Bradford Soil and Water Conservation District's Questions About the Chemours Trail Ridge South Mine in Bradford and Clay Counties Florida

Paul Still **904 368-0291** stillpe@aol.com **5/8/2024**

Based on the information about the Chemours Trail Ridge South (TRS) Mine in the documents we found in OCULUS, and the 1/29/2024 Google Earth imagery of the TRS Mine Bradford Soil and Water Conservation District (BSWCD) has several concerns about the operation of the TRS Mine on Suwannee River Water Management District (SRWMD) property in Bradford County. The BSWCD believes that answers to the questions asked in this document will help reduce the chances of environmental impacts from the operation of the Chemours TRS Mine in the future and the failure of stormwater containment systems during and after significant rain events. The predictions that this may be a year with an active hurricane season should be a consideration in obtaining answers to the BSWCD questions.

Figure 10 Attachments MMR_137482-018

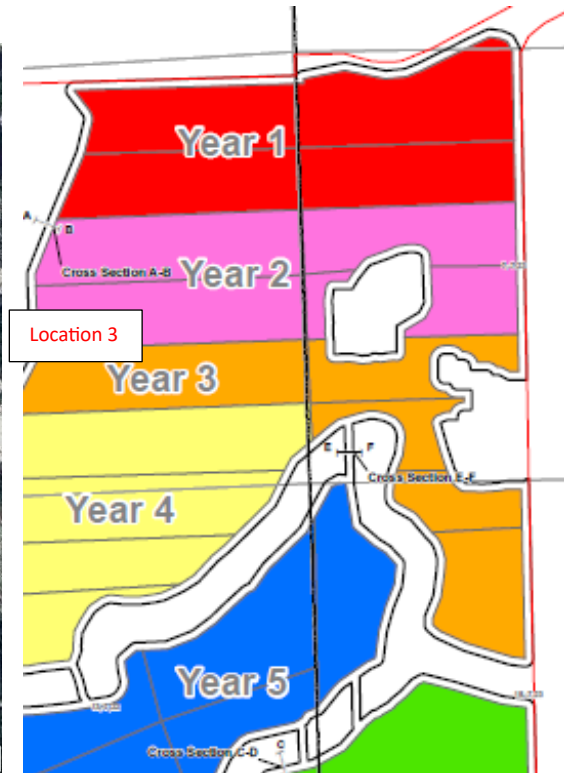
The disturbed area in the Google Earth image does not appear to match that area noted in the two different Figure 10 images from the two permits.

Do the activities seen in the Google Earth image meet permit requirements with respect to timing of mining activities?

Should the two Figure 10 maps be updated with a permit modification?

Figure 10 Permit No: ST404_137482-022

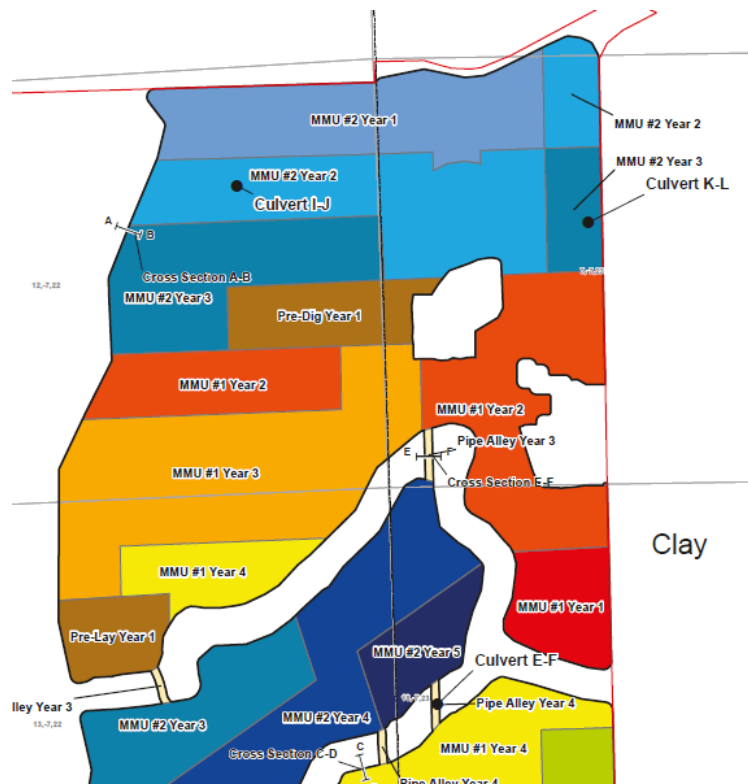
Figure 10 of Permit No: ST404_137482-022 copied on page 3 of this document appears to place the pre-dig pit in the Location 2 of the Google Earth images.

2023 Annual Report Figure 1

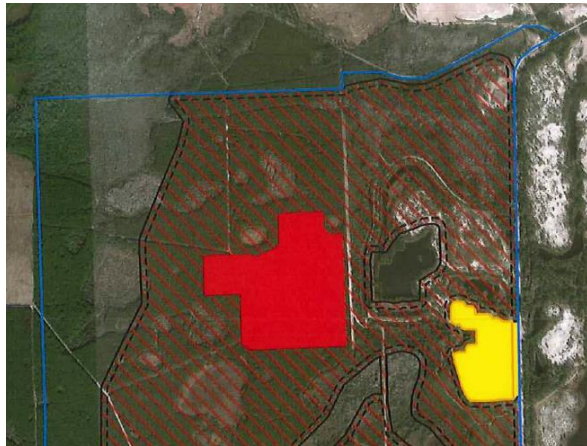
What is the difference between Permit Boundary, Boundary Permit, and Mining Limit?

What is the difference between Mined and Disturbed & Mined?

2022 and 2023 Annual Report Figures

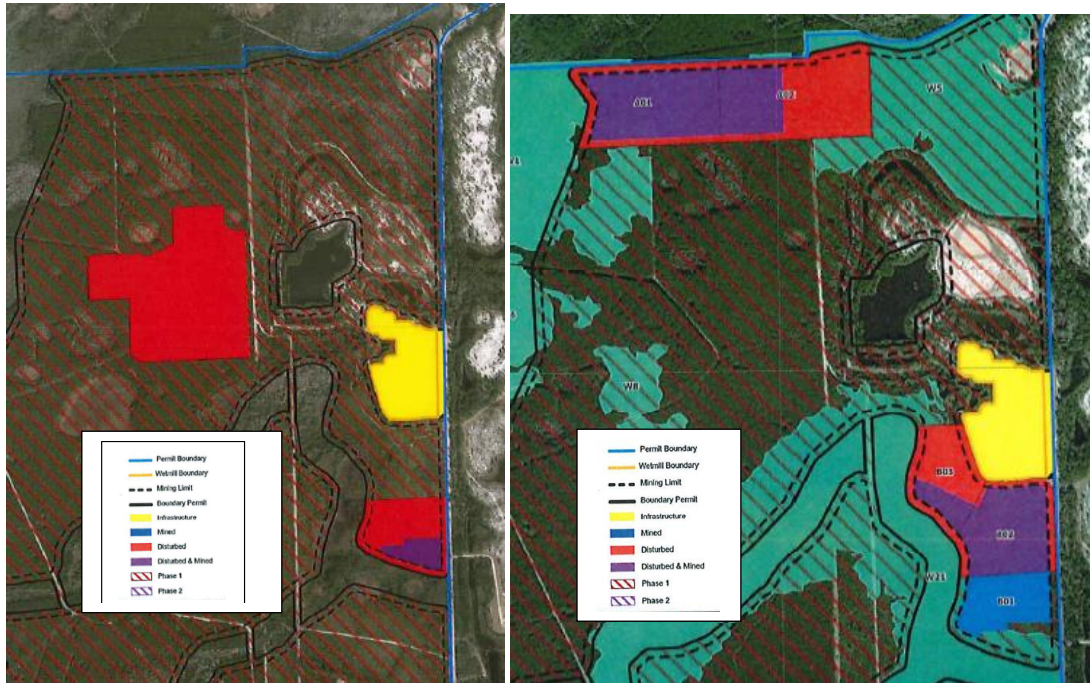
Since the heavy mineral sands have been removed and stockpiled, should the pre-dig pit area in tan in the image on the right be shown as disturbed & mined in the image on the left?

If there was a pit associated with the 2023 tailed area, how deep was the pit?

What is the area of the 2023 tailed area?

Is Figure 1 from the 2023 Annual Report misleading because it does not show the disturbance noted in the 2022 Annual Report and the current conditions seen in the 1/29/2024 Google Earth Imagery?

From 2023 Annual Report Figure 3
Reclamation Status 2023

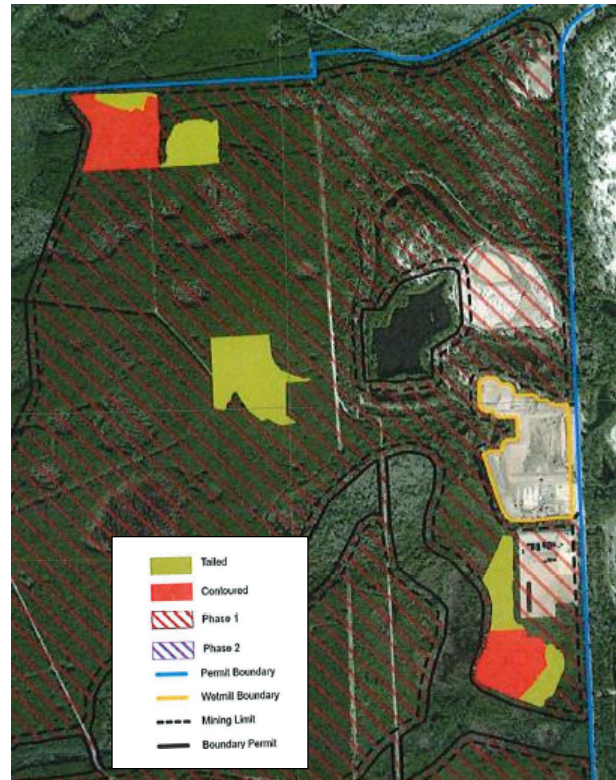
Does the 2023 Annual Report accurately describe the disturbance, mining tailing, and contouring in the Google Earth image?

Why is the area in the lower right shown as phase 1 when it appears to have been mined and is covered with water in the Google Earth image?

Are the parts of Locations 1, 2, and 4 that are filled with water being used to avoid discharging water and reporting on water quality requirements?

Should the water in Locations 1, 2, and 4 be analyzed for constituents such as radium, barium, and iron to determine potential impacts on groundwater?

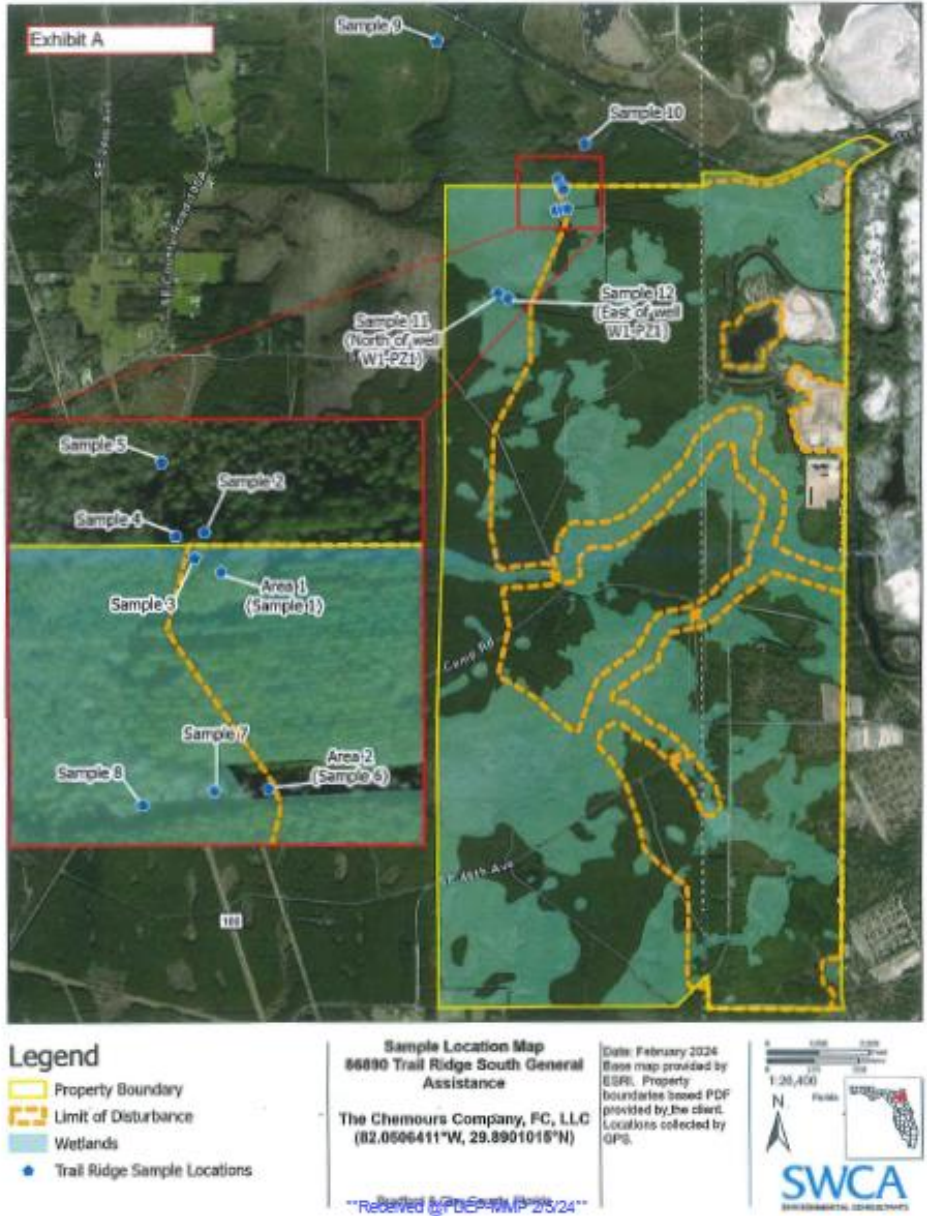
What data were used to establish that “there was no sediment deposition within the offsite wetlands”?

Are Samples 2 and Sample 4 on NFLT property?

Why is the location of the berm breach not shown on the image?

Why is the location of the berm overtopping not shown on the image?

Where is the mine cell pit that was receiving the process pond water?

What data would support the flow being toward the Samples 9 and 10 locations?

Northwest Corner Reclamation cell – Where water entered wetland
(January 31, 2024)

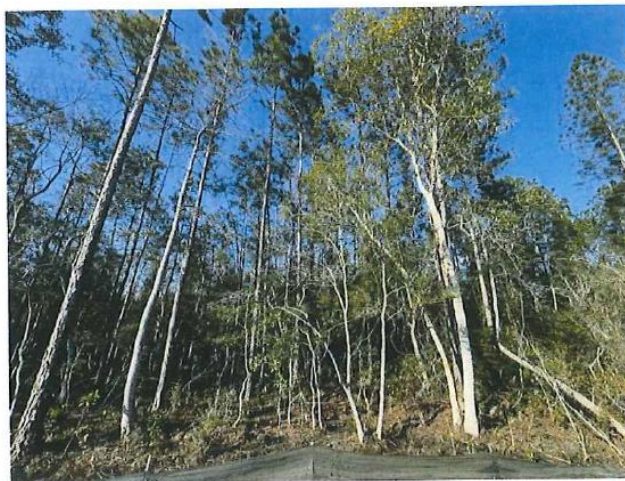
Is the above image from Area 1?
Page 7

What is the exact location of this image?

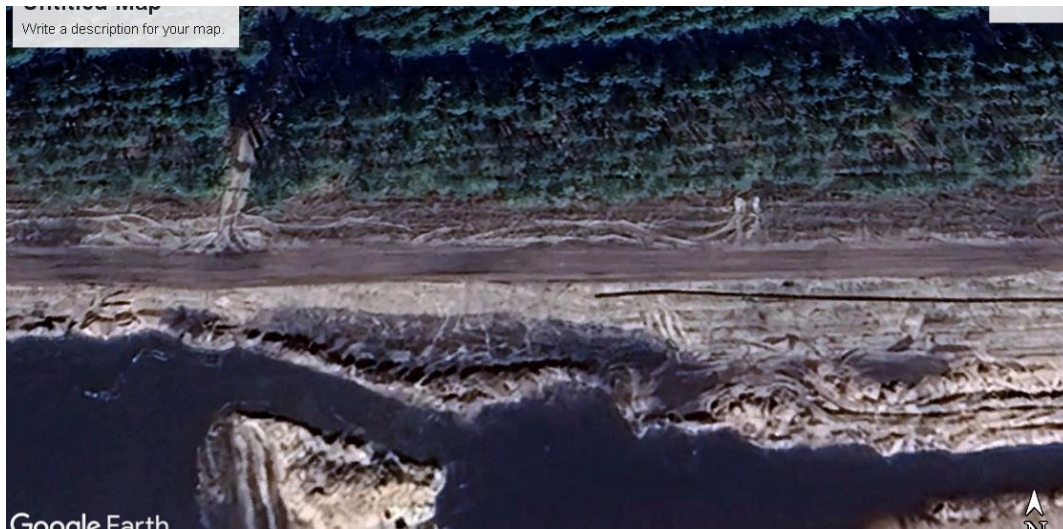
The pump in the Google Earth image above appears to be the same pump as in the image from 1/31/2024 on page 23 of this document. Based on the position of the black pipe just inside of the berm, it appears that there was significantly more water on 1/31/2024 than was present on 1/29/2024.

Does the berm at the water edge in the 1/31/2024 image meet the design requirements of the permitter berm?

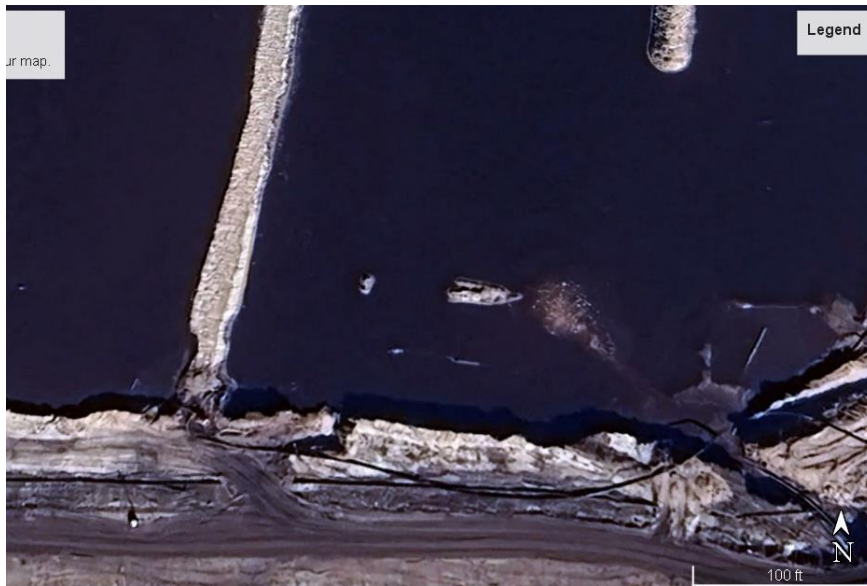
Why was the north south berm cut through on its northern end?

Was there any indication on 1/29/2024 that water was seeping through the thin berm section where the black pipe becomes visible?

Was there seepage in this area on 1/31/2024?

Why was this breach in the north south berm allowed to remain?

Is the berm failure in the above image of the north south berm the failure noted in the 5 day report that stated a *“washout” by the active tailings line which caused water to flow back toward the reclamation cell.*”

What is/was the purpose of the pump at the end of the north south berm?

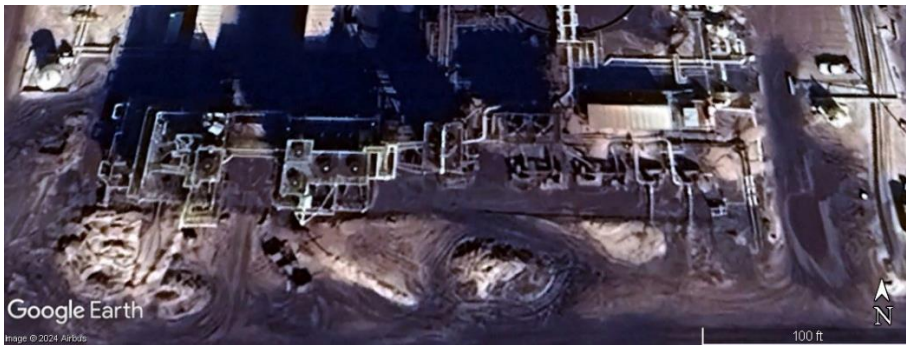
After the addition of process water on 1/30/2024 was the system *capable of containing the runoff from a 25-year, 24-hour storm event?* and

Did the groundwater level meet the permit requirement that *Groundwater will be maintained a minimum of 1-foot below ground surface?*
